Subject: Issuance of Amendment No. 16 to Facility Operating License
NPF-9 - McGuire Nuclear Station, Unit 1

MCGUIRE NUCLEAR STATION, UNIT 1

Amendment No. 16
License No. NPF-9

SAFETY EVALUATION BY THE
OFFICE OF NUCLEAR REACTOR REGULATION
RELATED TO AMENDMENT NO. 16
TO LICENSE NPF-9
DUKE POWER COMPANY

Figure 6.2-1 Offsite Organization

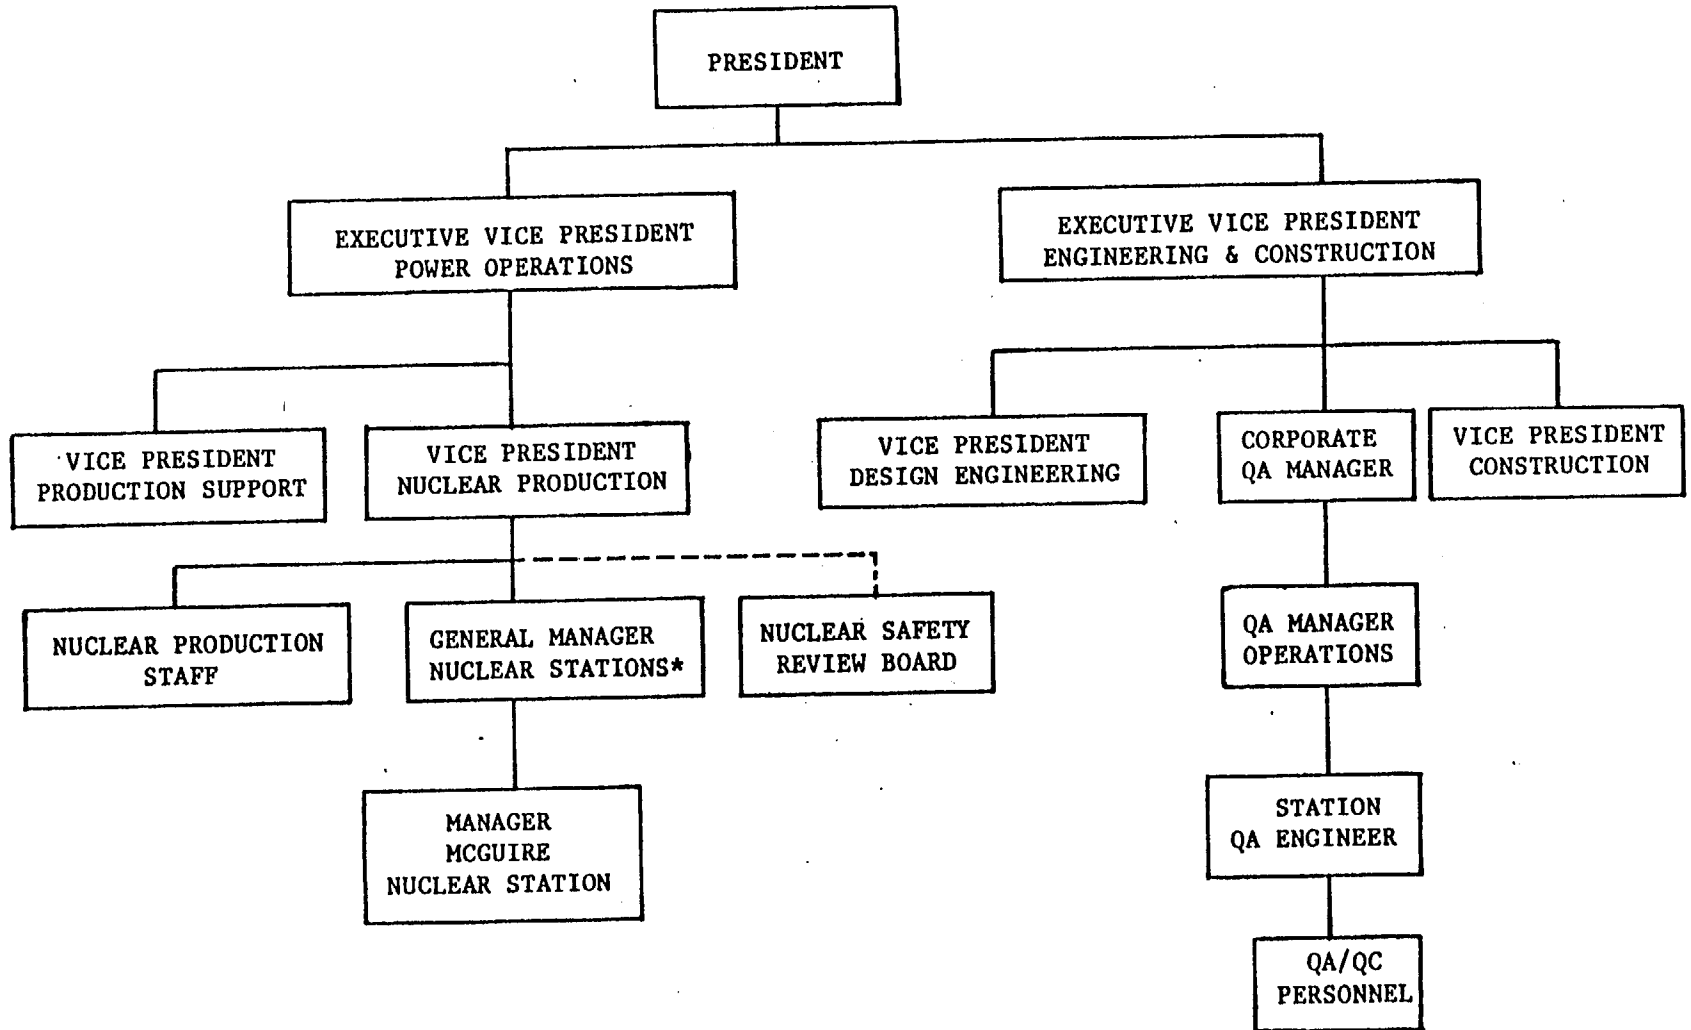
The current McGuire Technical Specifications show the nuclear station manager reporting to the Manager Nuclear Production who in turn reports to the Vice President, Steam Production. The proposed reorganization divides the functions of the Vice President, Steam Production into three positions: Vice President, Nuclear Production; Vice President, Fossil Production; and Vice President, Production Support. Reporting to the Vice President, Nuclear Production will be a General Manager, Nuclear Stations to whom the Nuclear Station Managers will report. Also reporting to the Vice President, Nuclear Production will be a Manager Nuclear Reliability Assurance, Manager Nuclear Safety Assurance, Manager Nuclear Operation, Manager Nuclear Maintenance, Manager Nuclear Technical Services, Manager Nuclear Engineering Services, Manager Nuclear Administrative Services and Manager Nuclear General Services.

Based on our evaluation, we consider that these proposed changes provide for better integration of those functions needed to support the operation of the nuclear station under a single high level corporate official and are acceptable. This is shown in the revised Technical Specifications Figure 6.1-2 and numerous text changes.

6.2.1 The offsite organization for unit management and technical support shall be as shown on Figure 6.2-1.

Figure 6.2-2 Station Organization

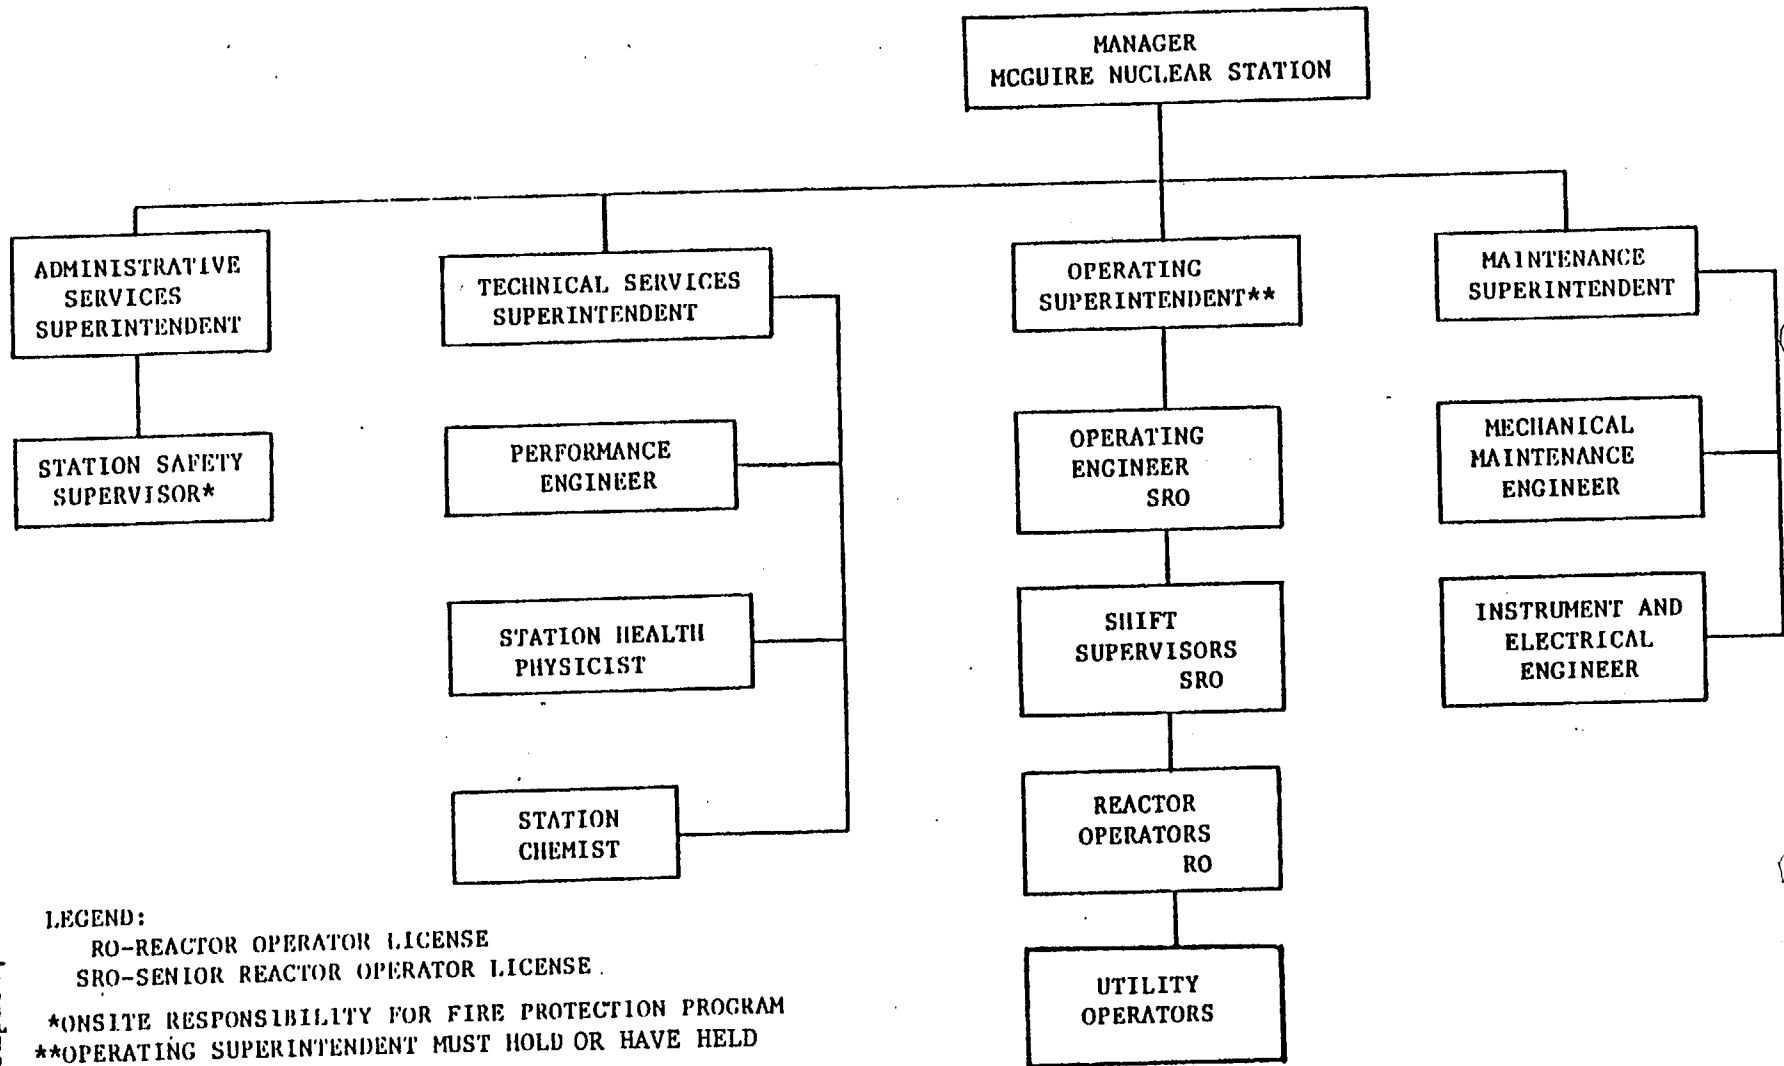
The current Technical Specifications show the Shift Supervisors reporting directly to the Operating Superintendent, who meets the qualification requirements for Operations Manager of Section 4.2.2 of ANSI/ANS 3.1-1978, "American National Standards for Selection and Training of Nuclear Power Plant Personnel," with an Operating

to upgrade the qualifications of the Shift Operating Engineer to that of the Operations Manager of Section 4.2.2 of ANSI/ANS 3.1-1978, and place the Shift Operating Engineer in a line position between the Shift Supervisors and the Operating Superintendent. This organization is reflected in revised Technical Specification Figure 6.1-1. The licensee proposes to alter the qualification requirements for the Operating Superintendent such that he must hold or have held a senior license on the unit.

Based on our evaluation, we find that the proposed organizational change is acceptable since the Shift Operating Engineer will meet the qualification requirements for the individual performing the function of Operations Manager of Section 4.2.2 of ANSI/ANS 3.1-1978 and meets the staff position of Revision 1 to Regulatory Guide 1.8.
